Arboricultural Opinion

The Water House, Millfield Lane, N6 6HQ.

Draft report of: Matthew Searle BSc (Hons), MICFor, MRTPI

Dated: 23rd February 2018

Figure 1 The Permanent Solution

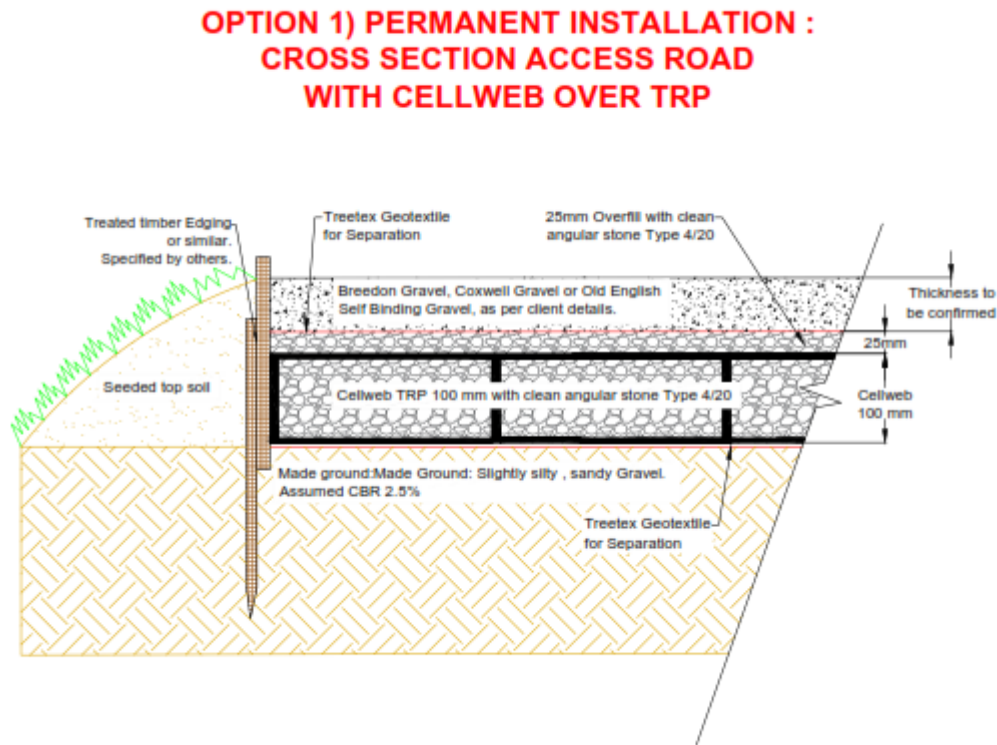
4.1.5. Having reviewed the submissions (set out in Appendix F) most notably the two consultant structural engineers reports and the Tree Root Radar survey, I am of the opinion that the permanent 'no dig' cellular confinement system specification in proximity to the three veteran trees, submitted by Geosynthetics Limited (and shown in Figure 1 below) would reduce any detrimental impact on existing tree roots, albeit that these impacts are likely to be minimal. The biggest gain when looking at the objectives (paragraph 1.3.2) would be the opportunity to also improve the rooting environment as part of the system.

4.1.7 In order to reduce further rutting and damage to the verges from construction traffic, I would therefore recommend a permanent cellular confinement system be installed in proximity to the three veteran trees, across the entire area of the Root Protection Areas (59.5 metres in length), the extent of which is delineated on the Tree Plan (Appendix C) and that the specification shown in figure 1 above is generally fit for purpose, but I would suggest the following amendments:

- Unless it can be demonstrated that the suggested surface finish of Breedon Gravel, Coxwell Gravel or Old English Self Binding Gravel are fully permeable over a number of years, an alternative surface layer solution should be found. Anecdotal evidence suggests such surfaces can silt up with fines, making them less and less porous over time. One of the key performance criteria required is a truly permeable construction that allows the roots and rooting environment to receive sufficient access to water, nutrients and oxygen.

- Only up to a maximum of 100mm be stripped off the current surface to enable the required leveling, although it is my understanding that the

Geosynthetics Limited solution does not require a completely level surface, having some flexibility to deal with undulations. This is recommended to protect existing tree roots.

- Any potholes, ruts or depressions to be filled BY HAND with inert materials including where possible, mulches and also soil and builders sand. Soft sand MUST NOT be used as it tends to contain salt, which is toxic to tree roots. This is recommended to protect existing tree roots and the rooting environment in which new tree roots can exploit.

- The seeded top soil edge to be graded so as not to exceed 200mm above existing ground levels. This is recommended to protect existing tree roots.
- The existing ground layer to be carefully forked BY HAND and have a mulch layer (supplied by The City Of London) and applied across the Root Protection Area.

- Banksmen/Bankswomen to ensure that no construction vehicles drive close to the edge of the cellular confinement system (also recommended by Adam Dawson).

- All installation to be overseen by Geosynthetics Limited.
- The installation, particularly the bottom layer, to be carried out with Arboricultural Supervision.

Figure 2 the Temporary Solution

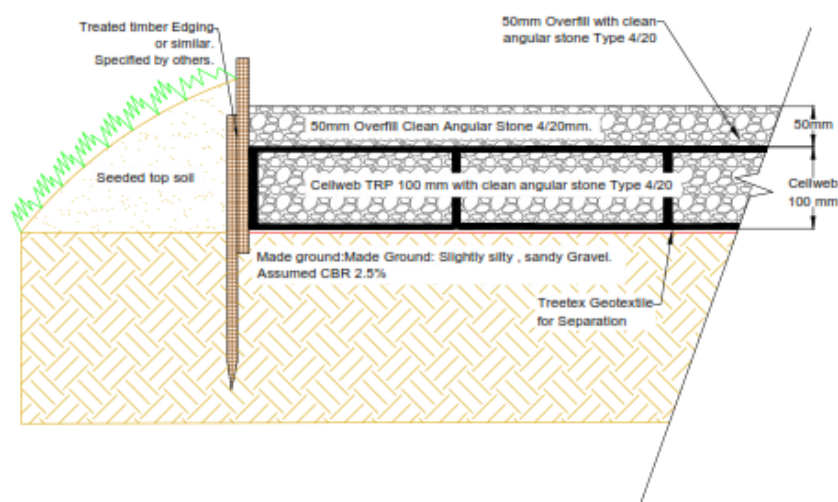
4.1.8 For the other mature trees along Millfield Lane, the majority of which are at least 4 metres from the track and at levels below 1 metres from the existing track ground level, I am of the opinion that whilst the proposed temporary solution (Figure 2 below) with my recommended additions set out in paragraphs 4.1.6 above would, in theory, be more than sufficient to protect any tree roots and their associated rooting environment, the installation process, including surface removal and leveling has the potential to cause more harm to tree roots and the rooting environment than is mitigated by the temporary system.

4.1.9 Other than leveling localized pot holes and depressions (as recommended by Andrew Dawson), my recommendation is to do nothing in the area outside of the Root Protection Areas of trees T1-T3, subject to the following necessary controls:

- Vehicle size, number of vehicle trips and the use of banksmen/bankswomen as set out in the traffic management plan.

- Vehicles to remain in the centre of the lane and not to track over the soft verges
- If it is not possible to track across the soft verges when turning into the Water House or following inspection, it becomes apparent that such has occurred, then all construction traffic ceased until the temporary solution is installed.

Drawing Title:
Tree Constraints Plan

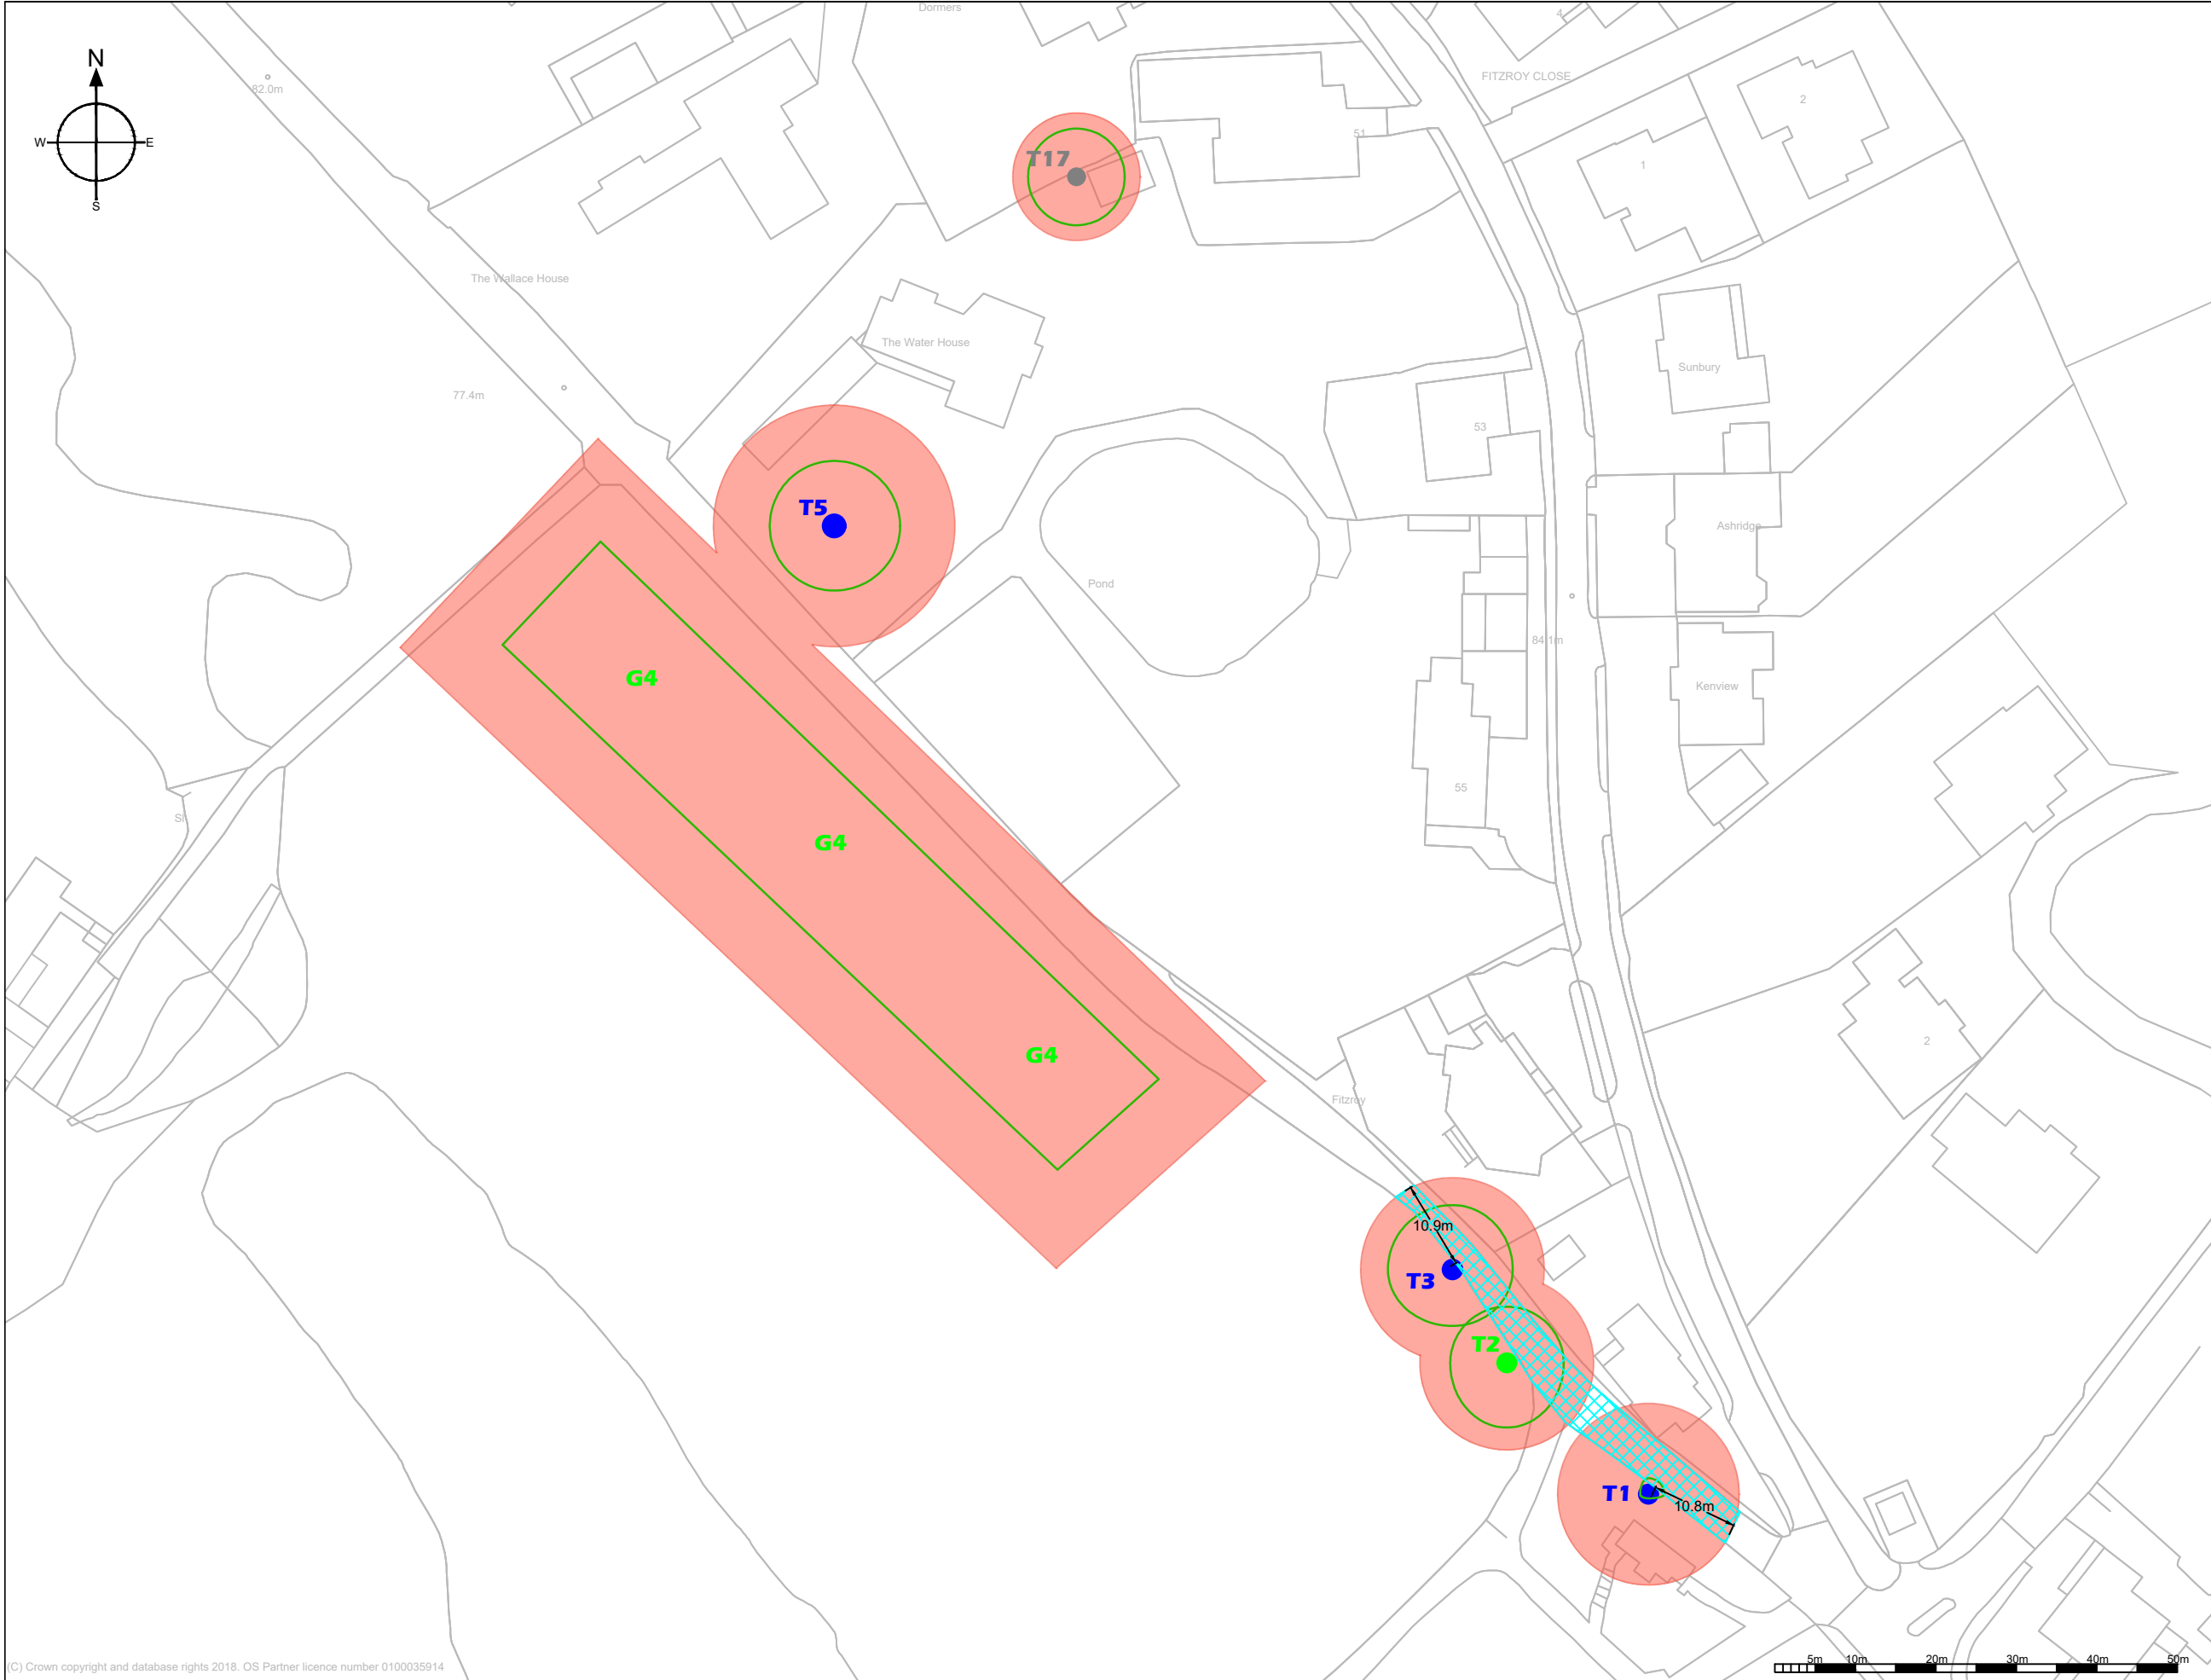
1.3.5 Other than leveling localised pot holes and depressions (as recommended by Andrew Dawson), my recommendation is to do nothing in the area outside of the permanent cellular confinement system, the extent on the tree plan (Appendix C), subject to the following necessary controls:

3.19 Three veteran oak trees (in proximity to the toilet block) along Millfield Lane (Trees T1,T2 & T3 on the Tree Plan, *Appendix C*) and a group of mature Horse Chestnut trees (G1 on the Tree Plan, *Appendix C*) are situated in potential influencing distance of Millfield Lane and could potentially be impacted by construction traffic using the lane.
